Safety Recall: 2019 Accord 2.0T Fuel Pump Motor

Supersedes 21-027, dated March 26, 2021, to revise the information highlighted in **yellow**

Under REPAIR PROCEDURE, steps 17, 27, 28, 29, 30, and 36 were revised.

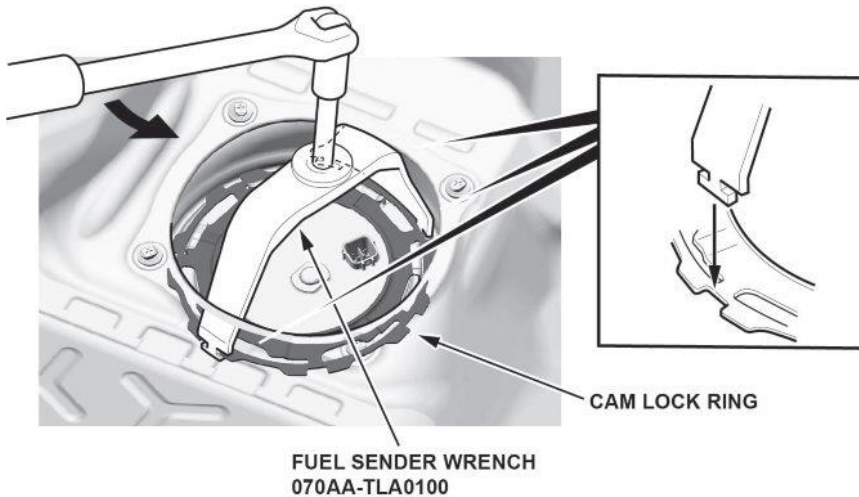
17. Turn the fuel tank unit cam lock ring counterclockwise to unlock it.

NOTE: After unlocking the fuel tank unit cam lock ring, clean the top of the fuel pump flange and adjacent areas to make sure it's free of dirt, dust, and debris.

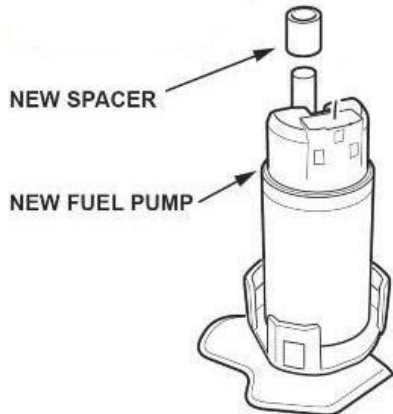
27. **Install the new spacer on the new fuel pump motor.**

28. Install the new O-ring, then lubricate the outside edge of it, use only clean engine oil.

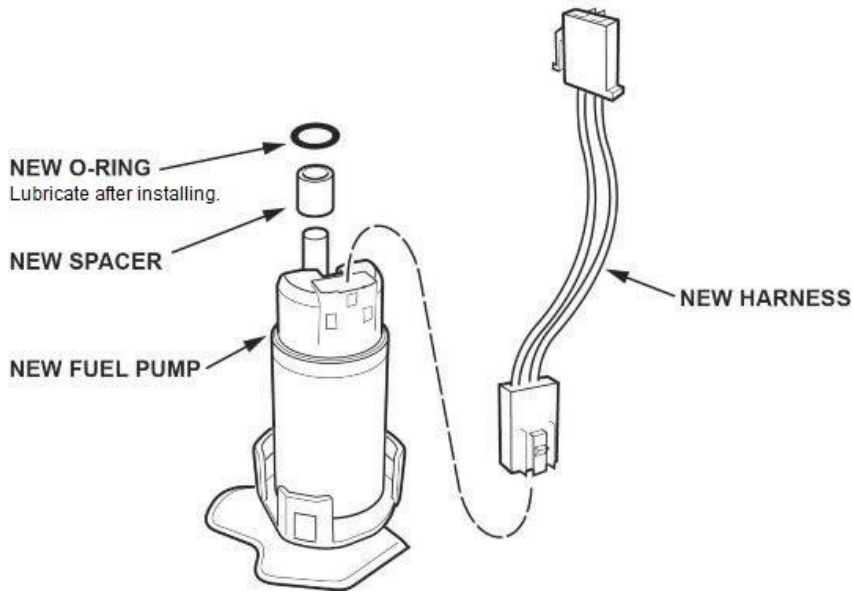
29. Install the new harness and make sure the connection is secure and the connectors are firmly locked into place.

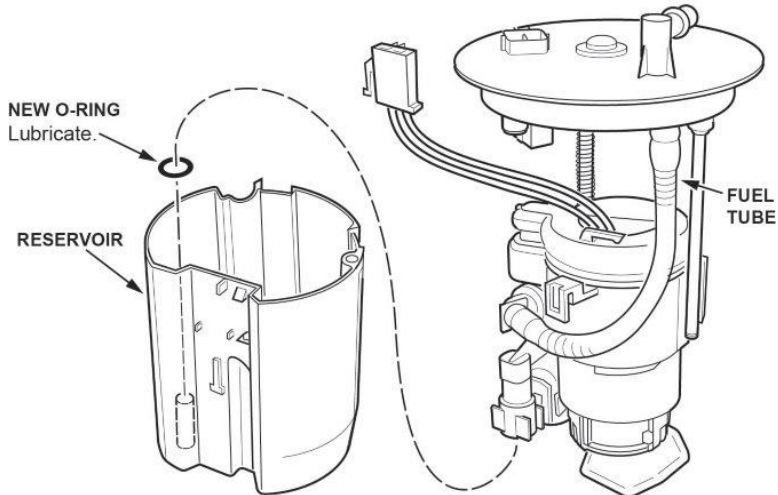
30. Place the fuel pump on a bench, then install the filter to the fuel pump.

NOTE: If the fuel pump does not engage into the fuel filter and re-insertion is necessary, confirm that the O-ring is seated on the fuel pump before repeating installation.

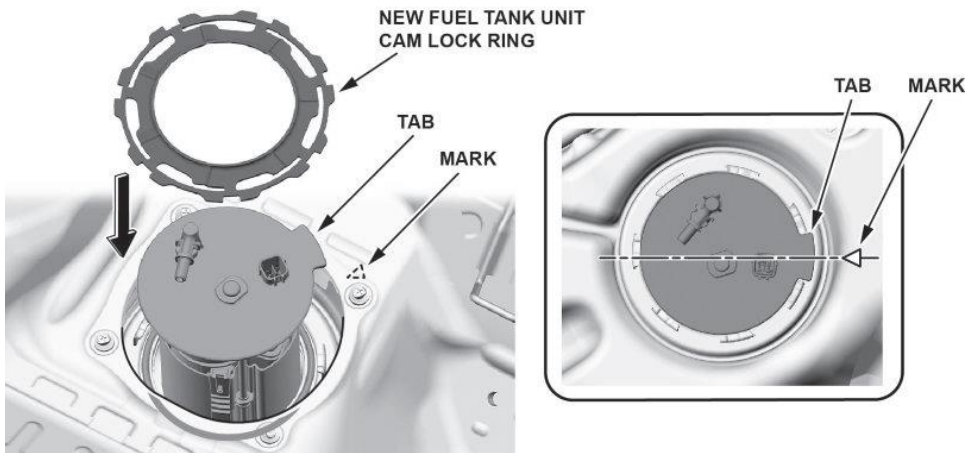
36. Install the fuel tank unit into the fuel tank with a new O-ring.

- Before installing the new O-ring, clean the fuel tank around the fuel pump opening where the O-ring will seat. The tank opening must be free of dirt, dust, and debris.
- Be careful not to damage the O-ring.
- Do not coat the O-ring with any oil.
